**Program Latihan Penguatkuasaan Untuk  
Pegawai JPS Bagi Pelaksanaan Perintah  
Kualiti Alam Sekeliling (Perwakilan Kuasa  
- Penyiasatan Ke Atas Kawalan Hakisan  
Dan Kelodakan)**

# BMPs INSPECTION

**Cad. Skim Perumahan 195 Unit Rumah Di Atas Lot  
30086 dan Lot 30087, Mukim Setapak, Kuala Lumpur  
oleh SUNWAY MELAWATI SDN BHD**

## EDP/0631/C/SD/ESCP/001

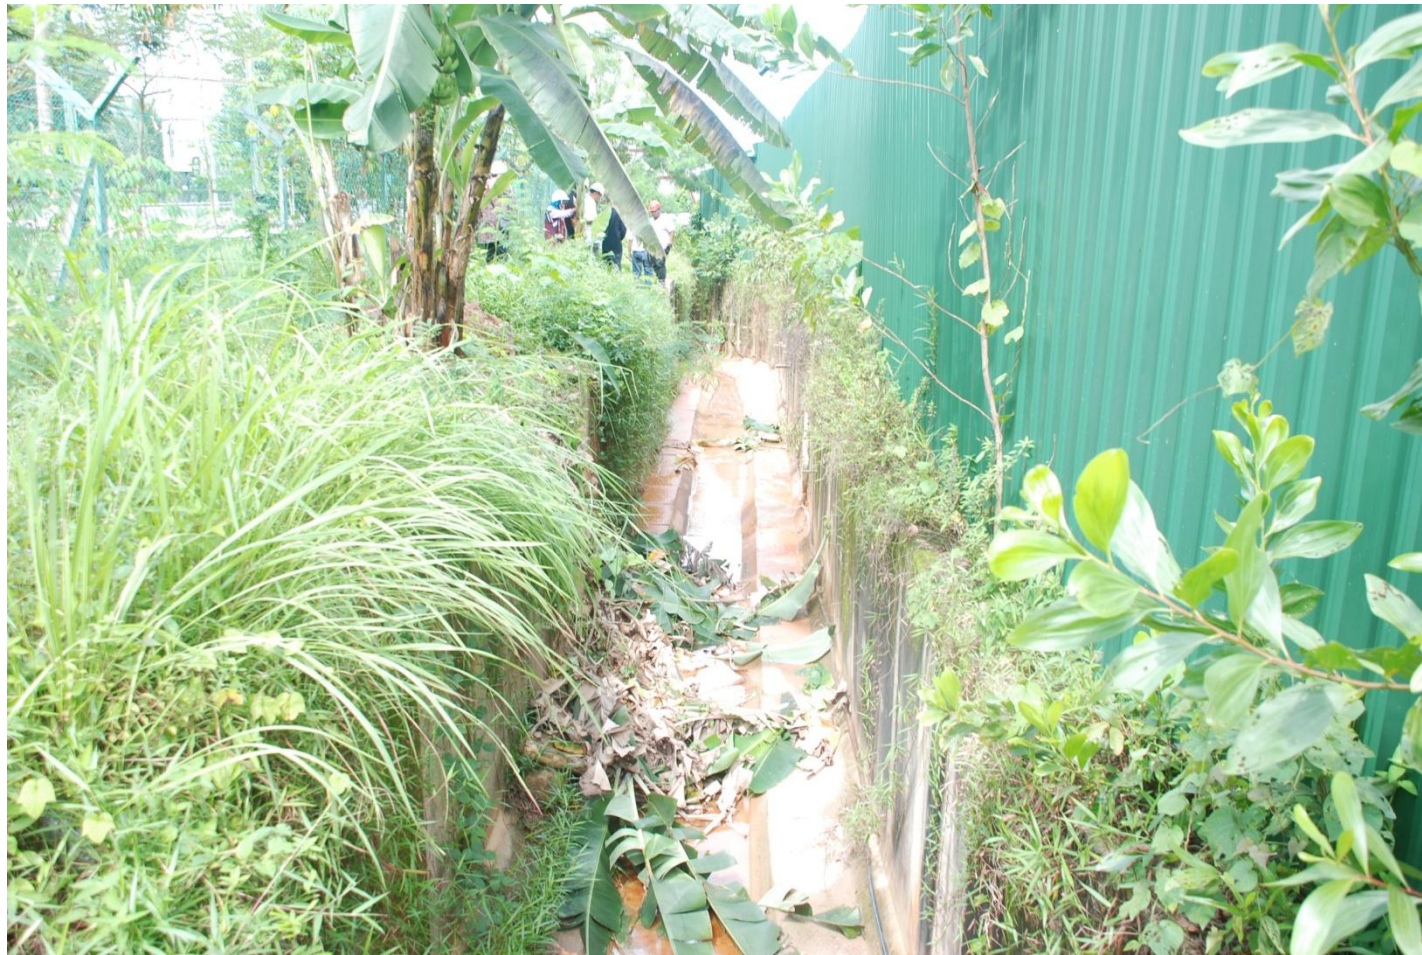
- ◆ Not a single effort to temporarily cover with seeding or hydroseed seen around this project area particularly active or changing site elevation and condition.

- ◆ EIA 4-08
- ◆ Notice S31
